DARCY ROAD PUBLIC SCHOOL

SSDA

Below are Landscape amendments from SSDA to DD.
Refer to SSDA-DD changes report & Landscape drawings for more details:

DRAWING TITLE
COVER SHEET

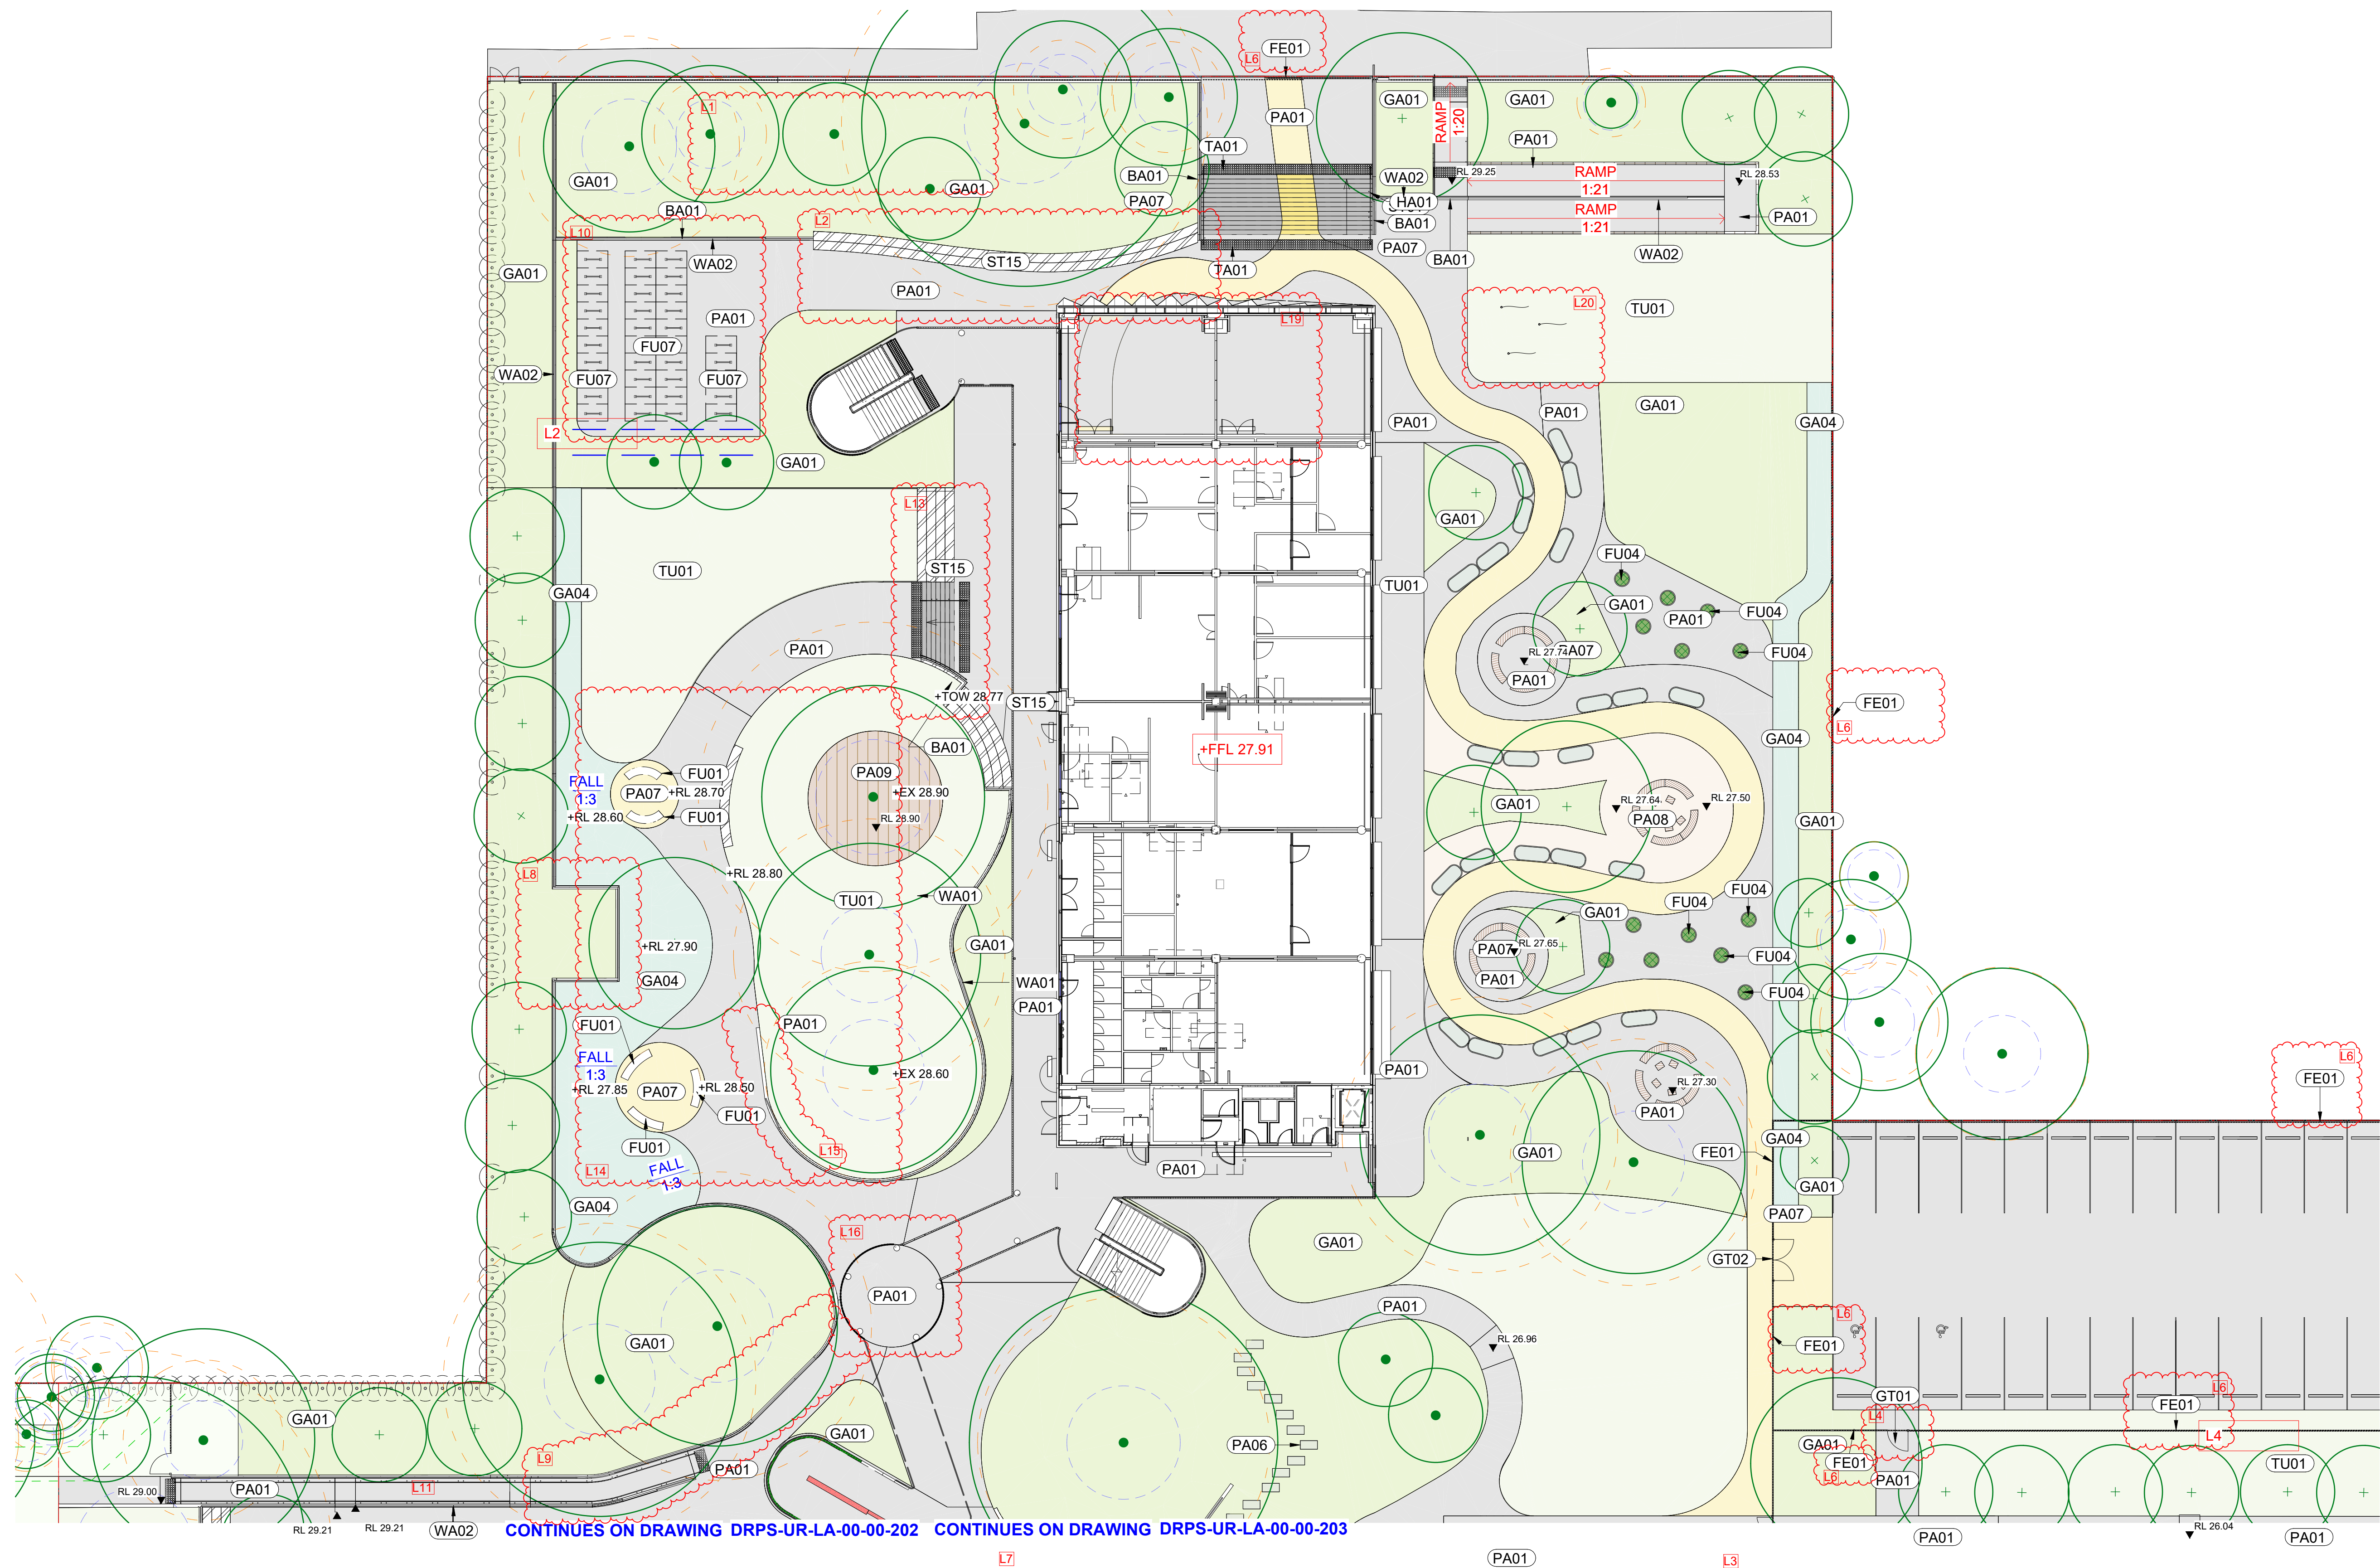
- L1. Existing ramp and stairs removed. Replacement trees proposed.
- L2. Northern Bleachers added in place of retaining wall
- L3. Gate 4 relocated to be adjacent to Building C

- L4. Gate 6 relocated to align with shared accessible pathway.
- L5. Gate 9 moved closer to building B on a footpath
- L6. Fencing type changes from yellow Corromesh to EFSG compliant Black Palisade

- L7. Walkway and roof linking COLA and Building B width reduced.
- L8. Western Flood wall pit
- L9. North of Block B Ramp and garden retaining wall amended

- L10. Bike parking amended
- L11. Library Plaza tree alignment amended. Number of trees retained.
- L12. Hatch added to the south decking east to Building A

- L13. Stairs added at entry from Building A to west gathering space. Bleacher length reduced on both sides of the stairs.
- L14. Planted swale and lawn extended to retain existing levels around tree T17-T19. Short bleacher added to retain existing level under T17.

- L15. Retaining wall extended around south of the lawn west to Building A to retain existing levels under tree T17-T19.
- L16. Seats removed
- L17. New connecting with Country / Water Country element proposed with dry creek bed.

- L18. Stairs and bleachers moved to east slightly to avoid the existing OSD tank.
- L19. Feature path realigned with the entry door at the north of Building A.

- L20. Flag poles x 3 added to the entry lawn.
- L21. Building C eastern walkway width reduced.
- L22. Relocation of stairs.
